ROADWAY DESIGN BULLETIN 12-11
DESIGN STANDARDS REVISION R1302(Revised)
DESIGN STANDARDS REVISION R2013-01
DCE MEMORANDUM 21-12
STRUCTURES DESIGN BULLETIN 12-09
ESTIMATES BULLETIN 12-07
(FHWA Approved: 7/27/2012)

SUBJECT: BARRIER AND TRAFFIC RAILING MOUNTED SIGNS
DESIGN STANDARDS REVISION (R1302), DATED JULY 1, 2012

SINGLE POST MEDIAN BARRIER
MOUNTED SIGN SUPPORT

INDEX NO.	SHEET NO.
11871	1

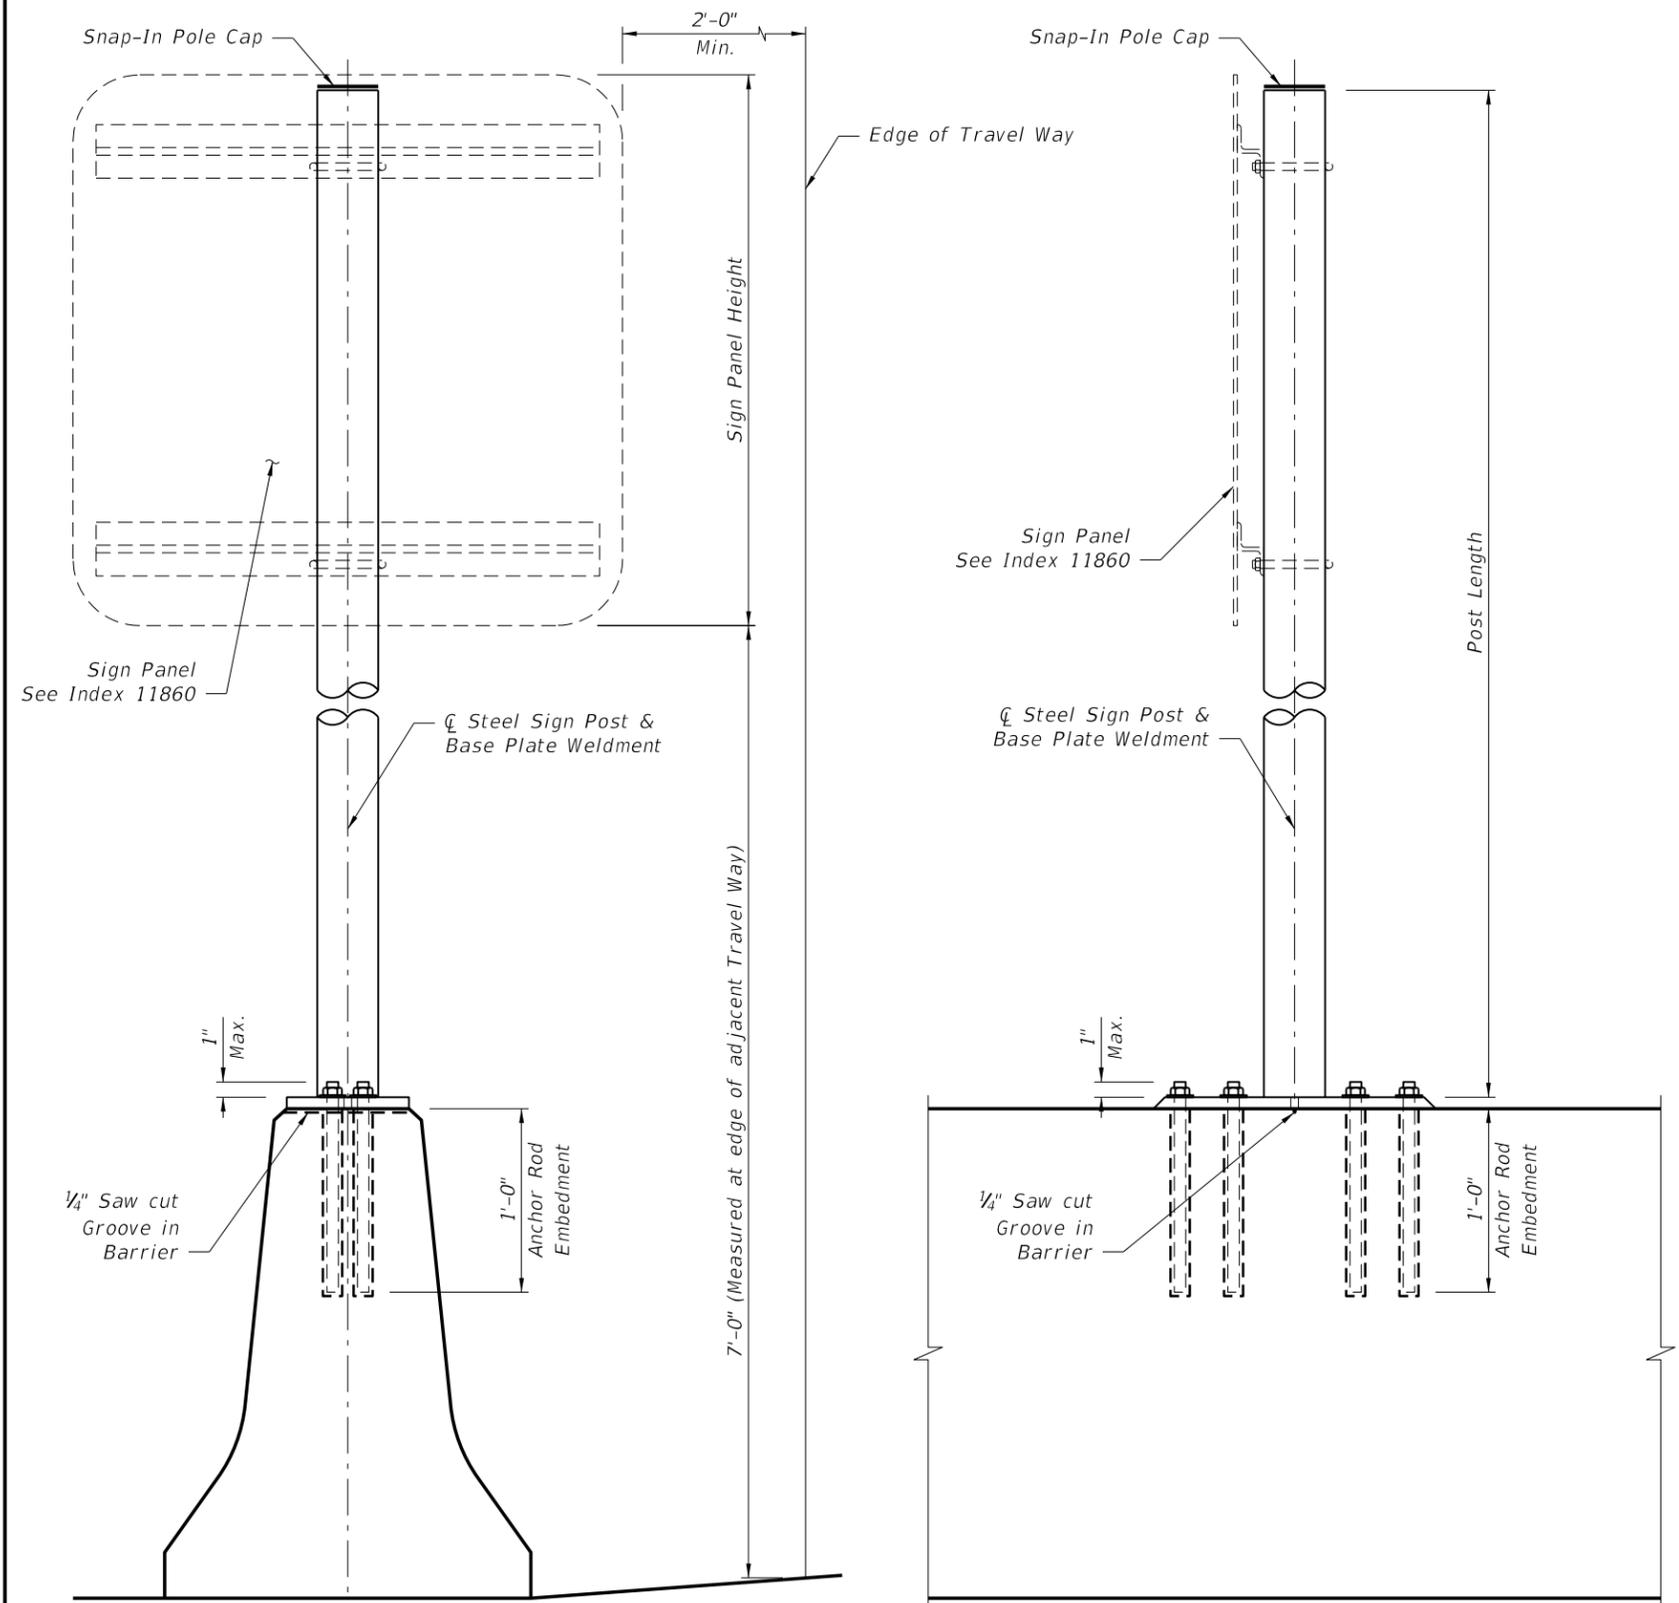
The Notes section of **Design Standards**, Index 11871 Single Post Median Barrier Mounted Sign Support (attached) is amended by adding the underlined text below:

Adhesive Bonding Material: Install anchor rods using Type HSHV Adhesive Bonding Material System in accordance with Specification Sections 416 & 937. For temporary sign support installations, the use of a metal detector specifically designed for locating steel in concrete is not required to locate existing reinforcement as stated within Specification Section 416-4. For temporary sign support installations, Specification Section 416-6 is not required. For permanent sign support installations, Specification Section 416-6 applies with the exception of the following: Perform field test on only one anchor per sign support location.

Adhesive Bonding Material: Install anchor rods using Type HSHV Adhesive Bonding Material System in accordance with Specification Sections 416 & 937. For temporary sign support installations, the use of a metal detector specifically designed for locating steel in concrete is not required to locate existing reinforcement as stated within Specification Section 416-4. For temporary sign support installations, Specification Section 416-6 is not required. For permanent sign support installations, Specification Section 416-6 applies with the exception of the following: Perform field test on only one anchor per sign support location.

LAST REVISION	DESCRIPTION:
07/27/12	R1302-- New Index R1302 (Revised)--Updated Adhesive Bonding Material requirements.
